**ON-SITE SEWAGE DISPOSAL SYSTEM
HOWARD COUNTY HEALTH DEPARTMENT
BUREAU OF ENVIRONMENTAL HEALTH**

REVISED PLOT PLAN
ERIK ROSENBAUM
LIBER 3880 AT FOLIO 19

THE PURPOSE OF THIS PLAN IS TO SHOW PROPOSED SEPTIC DESIGN.

PLOT PLAN
ERIK ROSENBAUM
LIBER 3880 AT FOLIO 19
14806 BUSHY PARK ROAD
FOURTH ELECTION DISTRICT
HOWARD COUNTY, MARYLAND
SCALE: 1" = 50' SEPTEMBER, 2005
REV: 9/20/05 SEPTIC

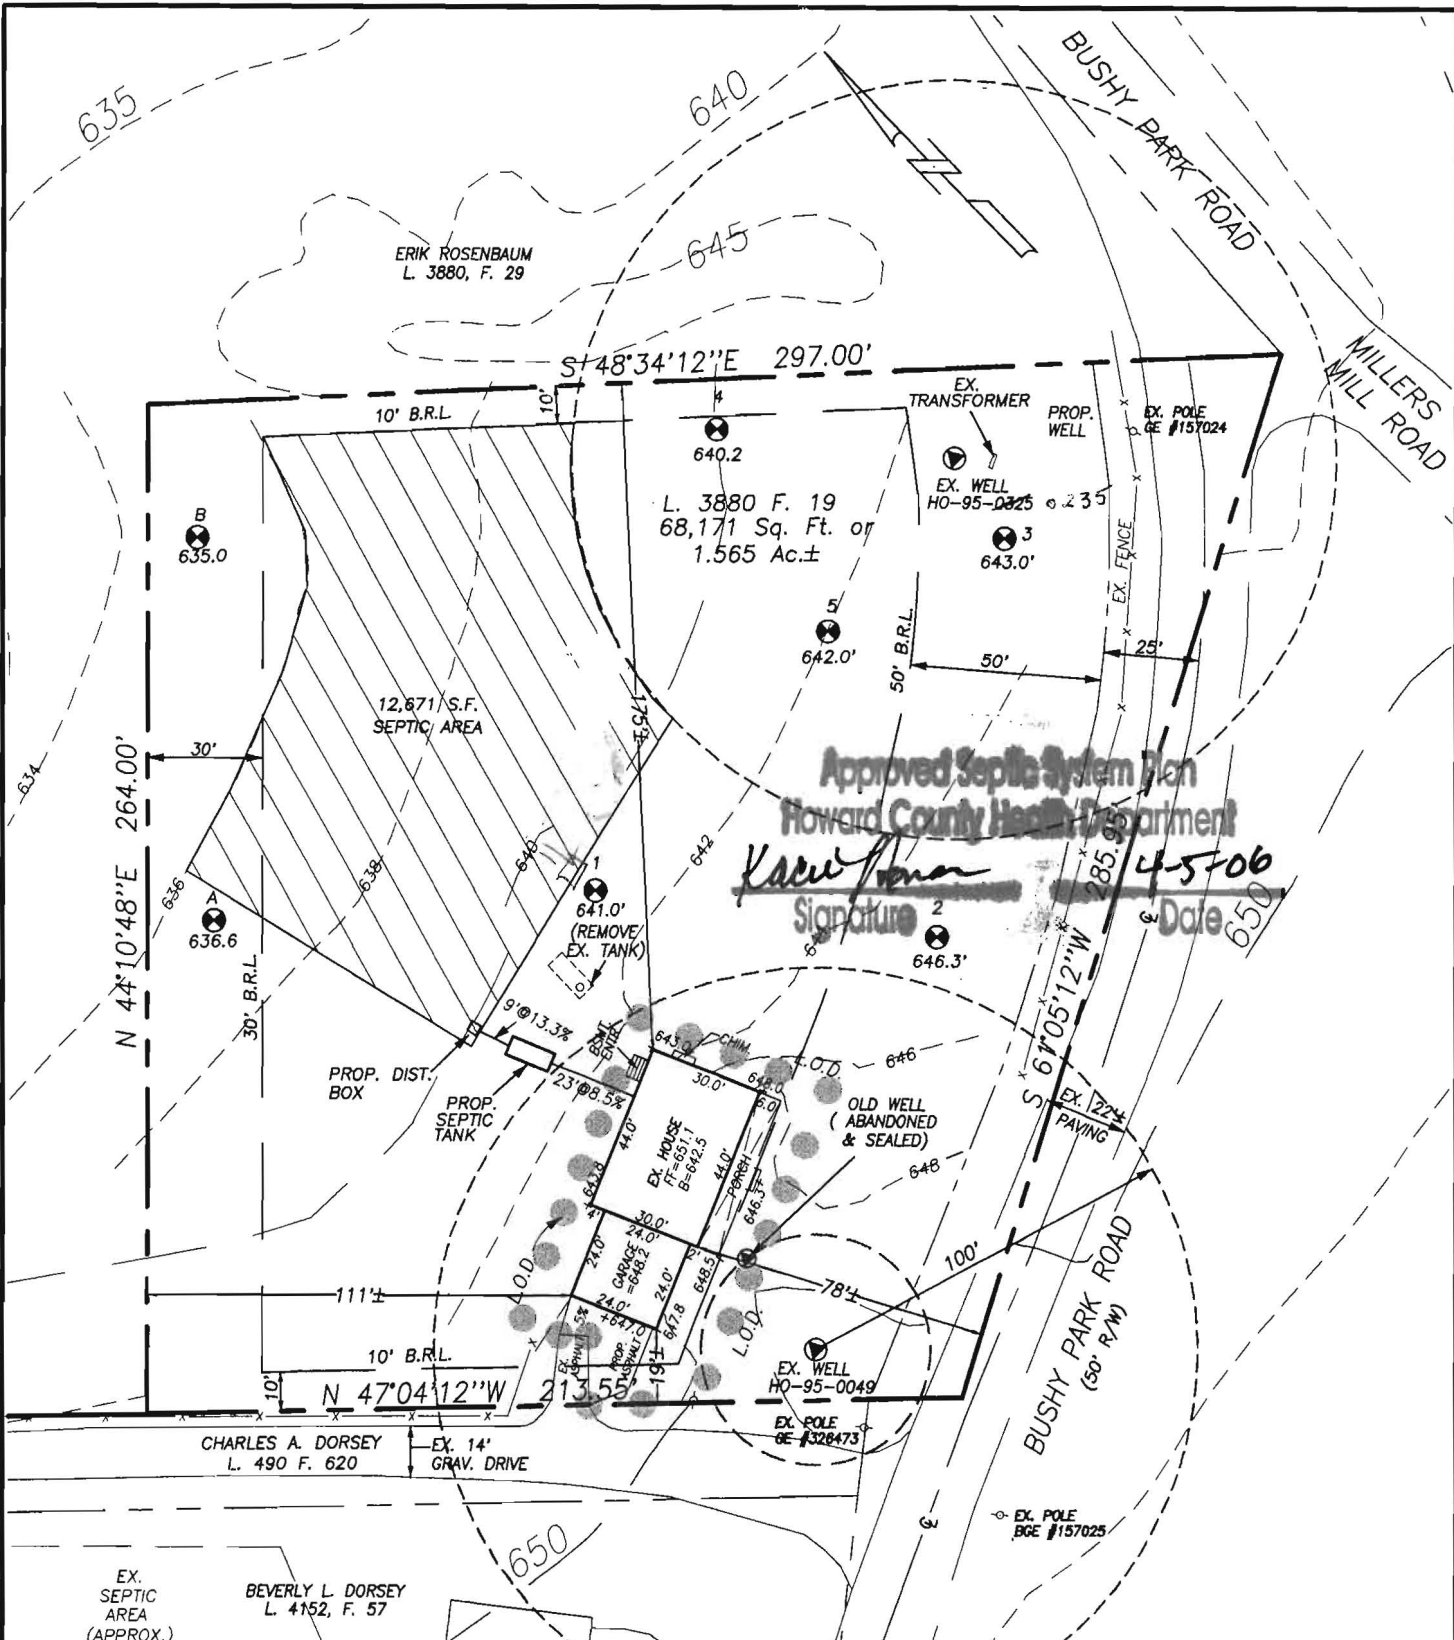
TRENCHES:	Trench to be 3.0 feet wide. Inlet 4.0 feet below original grade. Bottom maximum depth 8.0 feet below original grade. Effective area begins at 5.0 feet below original grade. 4.0 feet of stone below distribution pipe.
LOCATION:	Pump and collapse existing septic tank. Keep existing trench install 2-65' length trenches per plan. Connect distribution box to all three trenches.
NOTES:	Inspect condition of existing trench before hooking up. If well used, then do not connect. Recommend 1250 gallon septic tank or 1500 gallon.

PLOT PLAN
ERIK ROSENBAUM
LIBER 3880 AT FOLIO 19

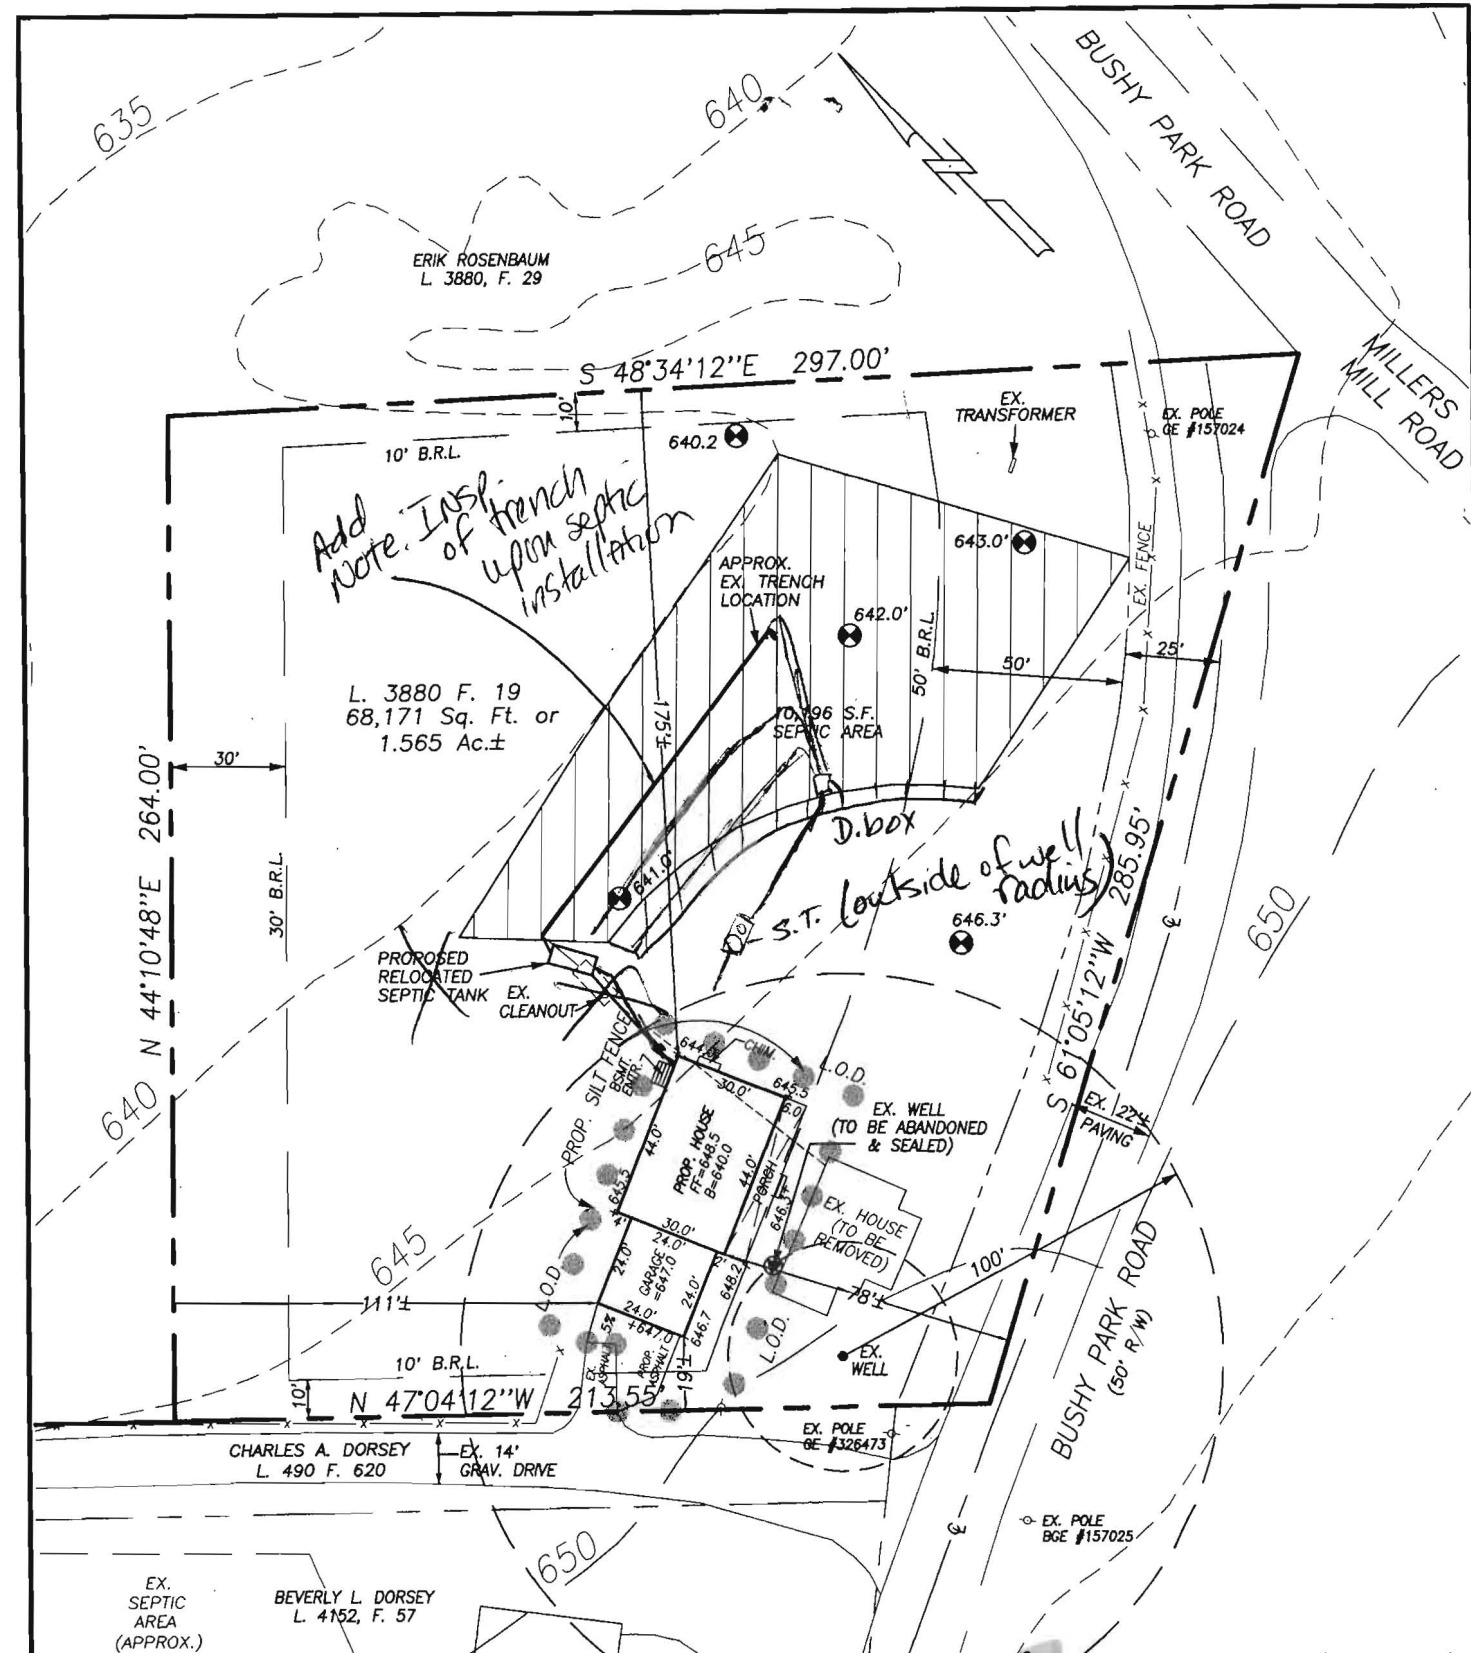
ENGINEER TO SHOW TWO-65' length trenches above existing trench 12' CTC. Relocate S Tank @ higher elevation. Need invert for SAN line

LOCATION DIAGRAM

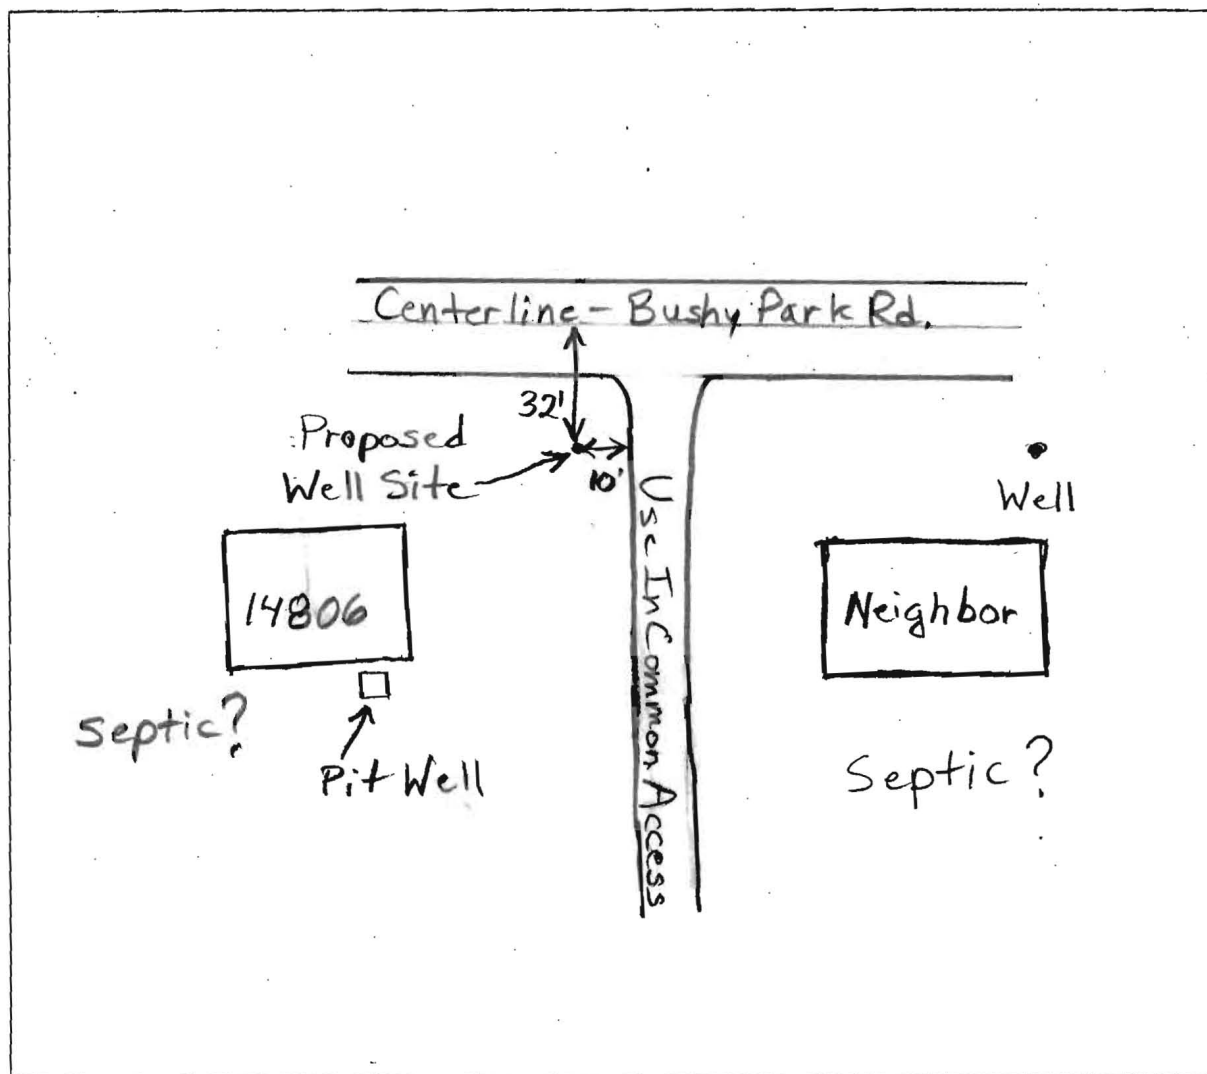
COMMENTS: Well site too close to Use In Common and may be too close to Bushy Park Road. Where are septic systems?
